Access Compliance Report

Public Rights-of-Way

Intersection ID: 5967	Main Street: TRYON_ST	Cross Street: MCCULLOUGH_DR	Location: NE
ADA ID: A6DCD86BBBF8	Ramp Type: BlendTrans1	Initial Pass/Fail: Pass	Overall Compliance: No
Severity Score: 5			
Codes/Mitigation Info/Possible Solution		Field Measurements/Component Compliance

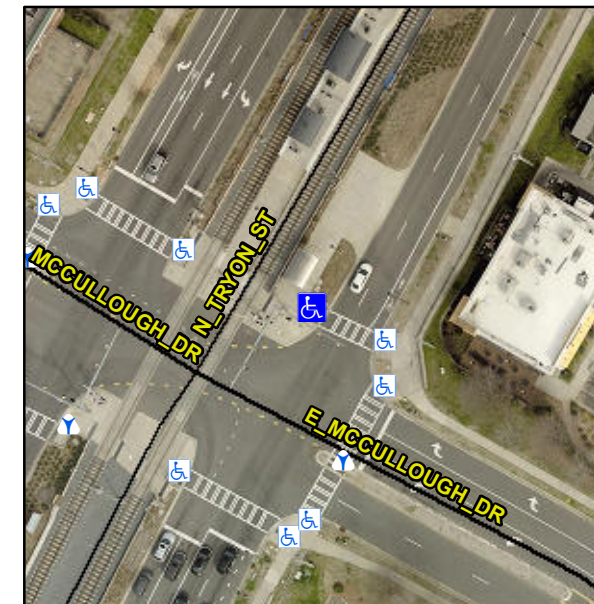
Remove & Replace Curb Ramp With Two New Directional Ramps or Equivalent.

R304.2.3, R305.2

Compliance	Description	Data	Compliance	Description	Data
N/A	Ramp Length (in)	237.0	Yes	BlendTrans Slope (%)	0.1
Yes	Ramp Width (in)	120.5	Yes	BlendTrans XSlope (%)	1.4
No	Flare Type	Curbed_WithWalkSurface	Yes	Flare Type	Curbed_NoWalkSurface
N/A	Flare Slope LT (%)	N/A	N/A	Flare Slope RT (%)	N/A
N/A	Flare Traversable LT?	No	N/A	Flare Traversable RT?	No
Yes	Landing Length (in)	90.0	Yes	DWS Provided?	Yes
Yes	Landing Width (in)	120.5	Yes	DWS Contrast?	Yes
Yes	Landing Slope (%)	1.4	Yes	DWS Length (in)	24.0
Yes	Landing X Slope (%)	0.6	Yes	DWS Full Width?	Yes
N/A	Landing Curb? (Y/N)	No	No	DWS Offset (in)	3.0
N/A	Shared Landing?	Yes			
Yes	Gutter Ponding?	No	Yes	Gutter Slope (%)	2.5
Yes	Gutter Lip Ht (in)	0.0	Yes	Gutter X Slope (%)	2.0
N/A	Painted X Walk1?	Yes	N/A	Painted X Walk2?	N/A
	X Walk 1 Direction	To SE		X Walk 2 Direction	N/A
	X Walk 1 Width (in)	108.0		X Walk 2 Width (in)	N/A
	X Walk 1 Slope (%)	3.4		X Walk 2 Slope (%)	N/A
